DEVELOPMENT APPLICATION ASSESSMENT REPORT

Application Number:	DA2021/2095
----------------------------	-------------

Responsible Officer:	Kye Miles
Land to be developed (Address):	Lot 10 DP 243387, 163 McCarrs Creek Road CHURCH POINT NSW 2105
Proposed Development:	Alterations and additions to Dwelling House
Zoning:	C4 Environmental Living
Development Permissible:	Yes
Existing Use Rights:	No
Consent Authority:	Northern Beaches Council
Land and Environment Court Action:	No
Owner:	Christopher Allen Horsley Deborah Jane Horsley
Applicant:	Deborah Jane Horsley

Figure 1. Building envelope encroachment.

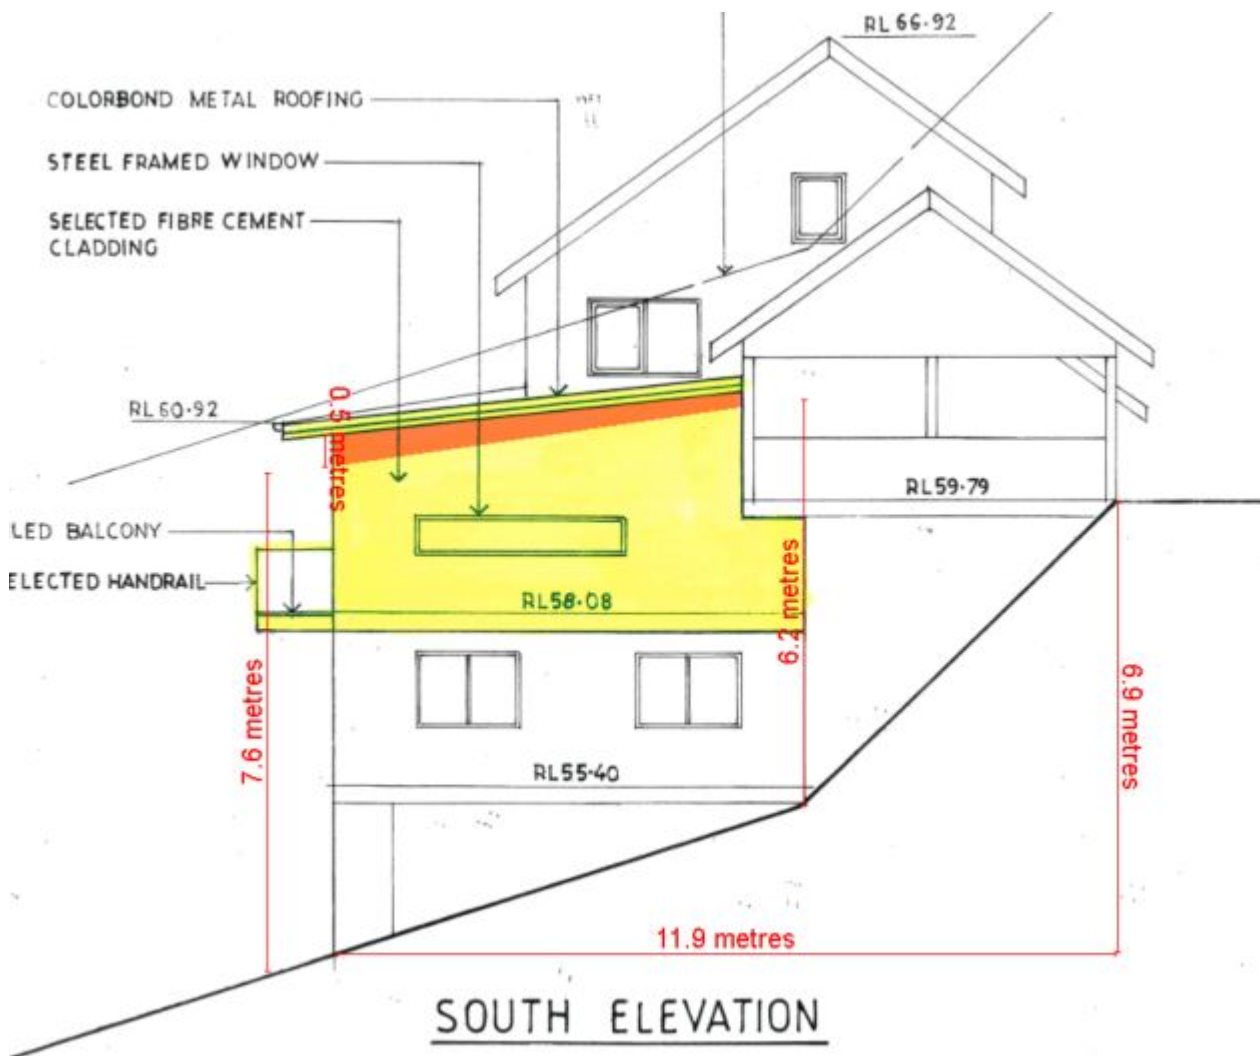
The control requires development to be within a building envelope projected at 45 degrees at a height of 3.5m above the side boundary.

The proposed kitchen addition caused a minor encroachment of the wall beyond the building envelope along the southern elevation up to 0.5m (10%).

Notwithstanding, the southern elevation is situated on a slope in excess of 30%, therefore, variation to this control will be considered on a merits basis.

Having regard to the above assessment, it is concluded that the proposed development is consistent with the relevant objectives of P21DCP and the objectives specified in s1.3 of the Environmental Planning and Assessment Act, 1979. Accordingly, this assessment finds that the proposal is supported, in this particular circumstance.
